# CITY OF HAYWARD AGENDA REPORT

Zone Change No. PL-2003-0533 & Vesting Tentative Tract Map 7470/PL-2003-0534 –Trumark Companies (Applicant)/ The Domoto Family Partners LP (Owner) – Request to Change the Zoning From an Agricultural (A) District to a Planned Development (PD) District and Subdivide 5 Acres to Build 50 Homes

The Project Location Is 26521 Whitman Street (former Domoto Nursery).

# **EXISTING TREE PLAN**

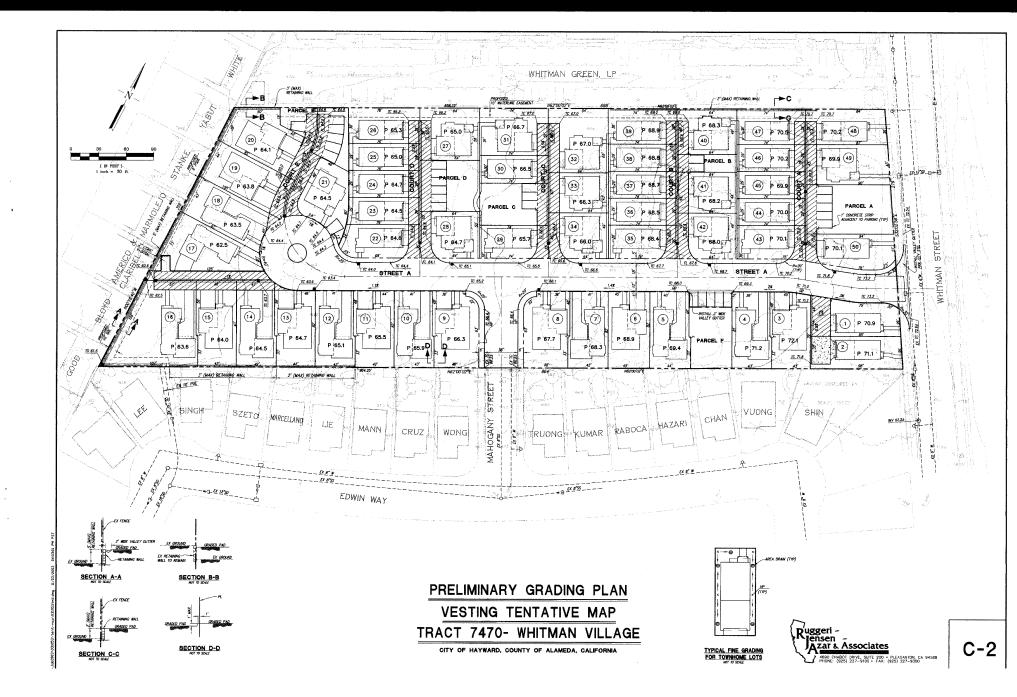
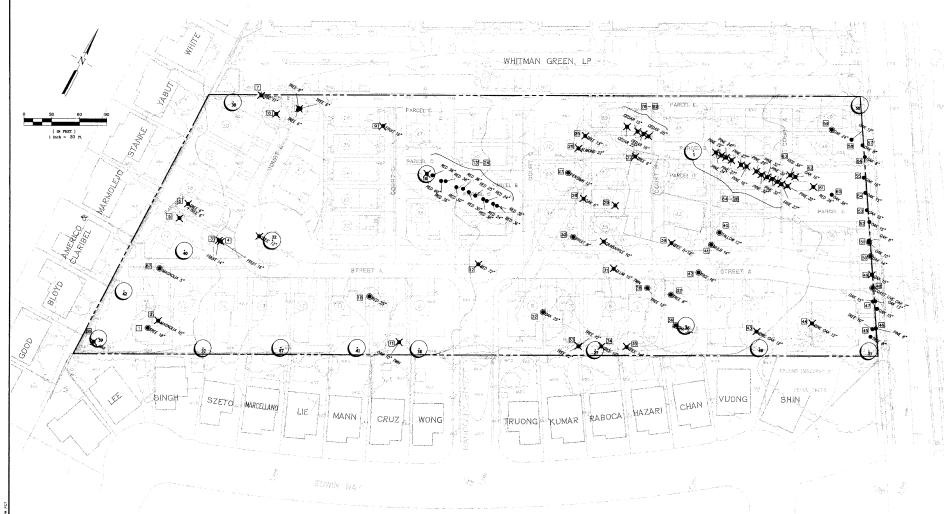
The project will require the removal of 45 of the 82 trees. Of the remaining 37 trees, 24 will be kept in place and 13 will be relocated within the site. The City's Landscape Architect has worked closely with the applicant to have the better trees protected or relocated. If the project is approved, replacement trees totaling in value equal to those removed would be required to be planted throughout the site. All the trees to be removed have been rated as being in moderate to poor health and structure. In staff's opinion, the dwelling on Lot 50 should be relocated or eliminated so that the footprint does not fall within the dripline of tree number 60. (See Sheet C-4 of the plans.)
